### **ADDENDUM NO. 1**

### **PROJECT # 18017 – HURRICANE HARVEY REPAIRS FOR BEN J. ROGERS REGIONAL VISITOR CENTER, 5055 IH-10 SOUTH, BEAUMONT, TEXAS 77705**

### **Sheet A1.0, 1/A1.0 Floor Plan**

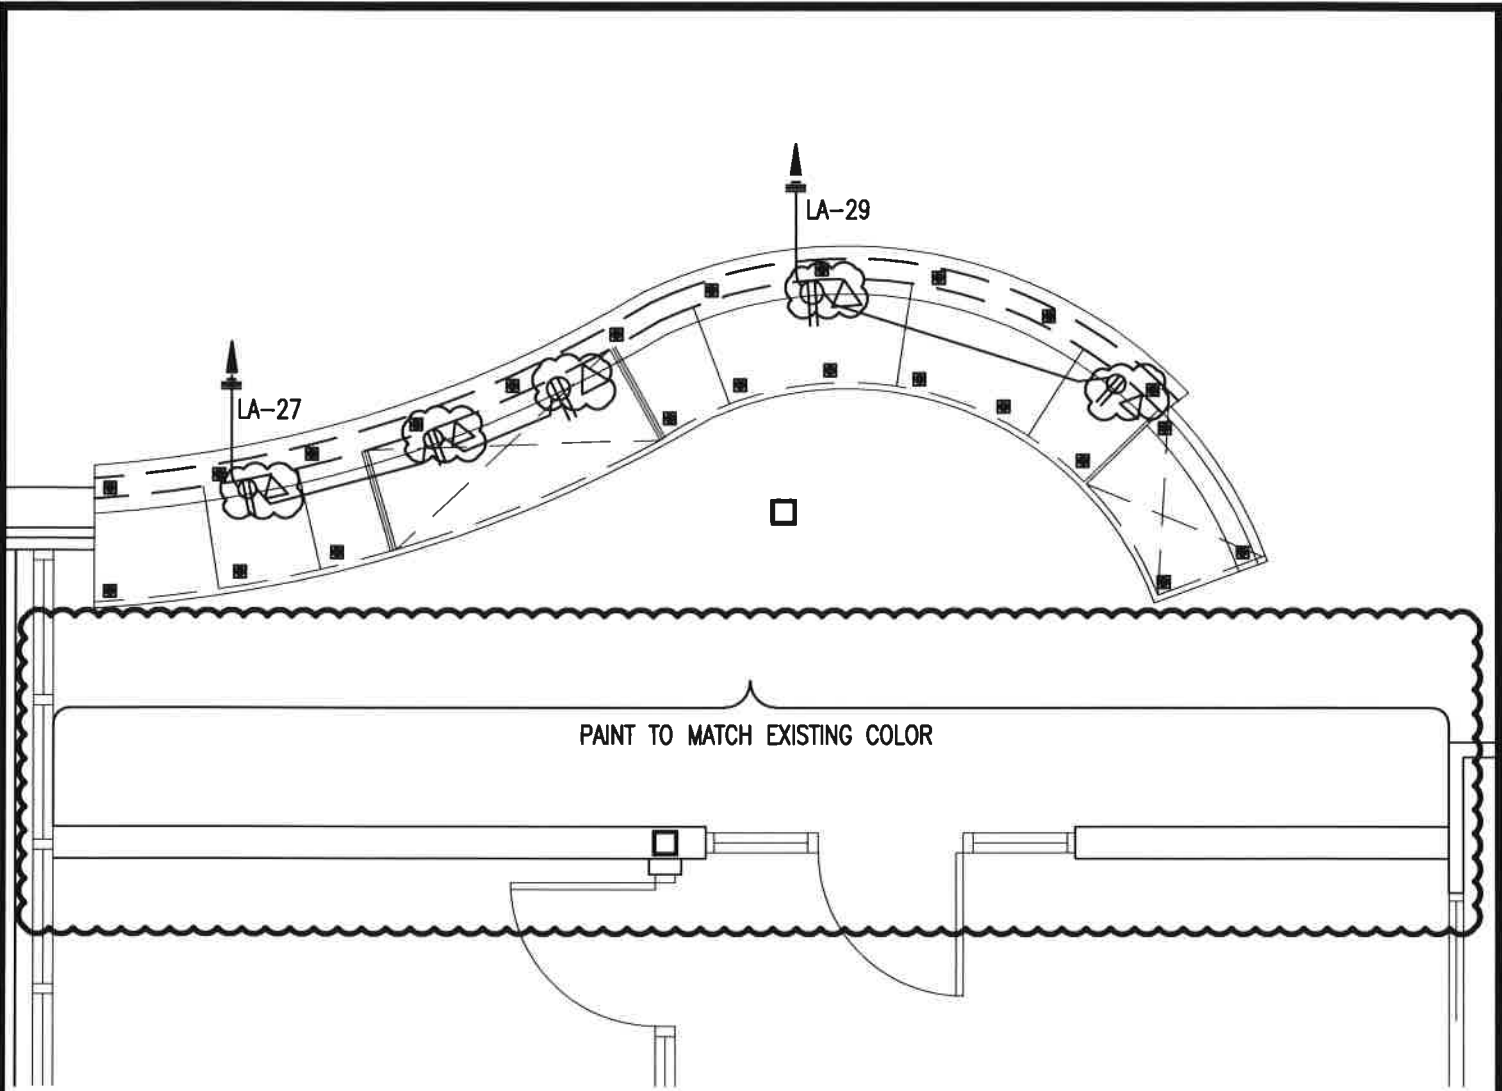
1. Add supplemental drawing SUP-2 for addition of trench drain and associated storm drain lines at Doors, #102 and #115.

# RECEPTION DESK PLAN

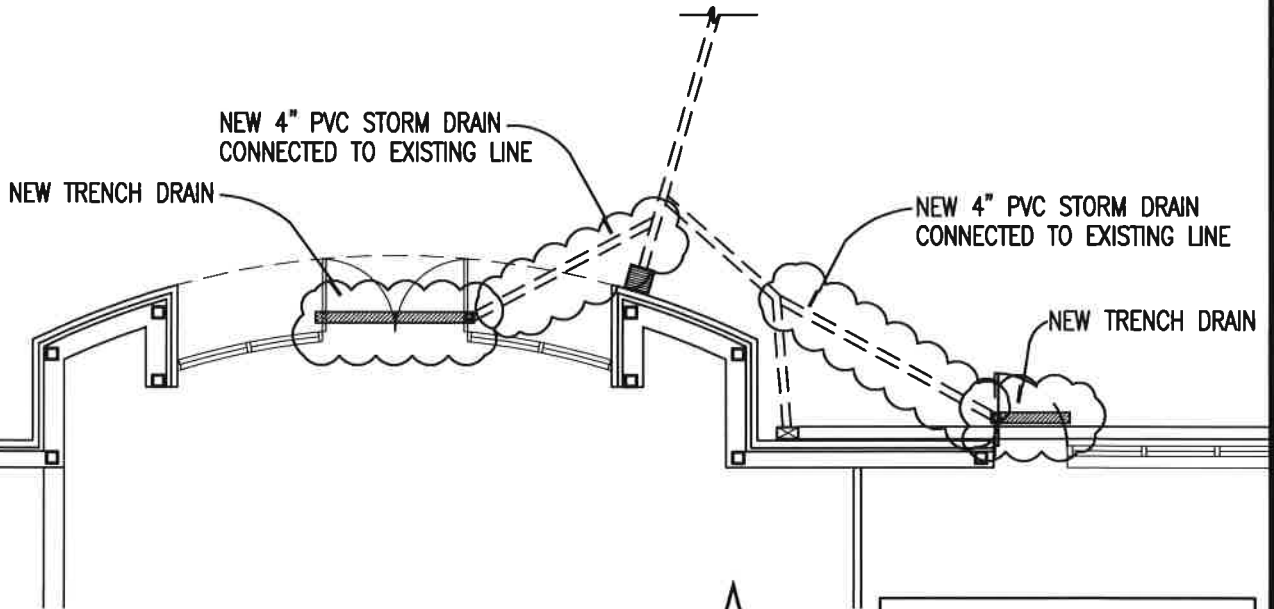
1. Add General Note #1 to read as follows: Entire surface of wall behind desk at Info Desk, #101 shall be painted. Refer to attached supplemental drawing SUP-1 for extent of wall to be painted. Paint color shall match existing paint color on wall. Submit sample for approval.
2. Add General Note #2 to read as follows: Contractor shall replace any rusted exterior metal studs that may be encountered during construction.
3. Add General Note #3 to read as follows: Contractor shall be responsible for relocating existing furniture as required to accommodate flooring installation.

1. Add supplemental drawing SUP-1 for addition of electrical and data outlets.
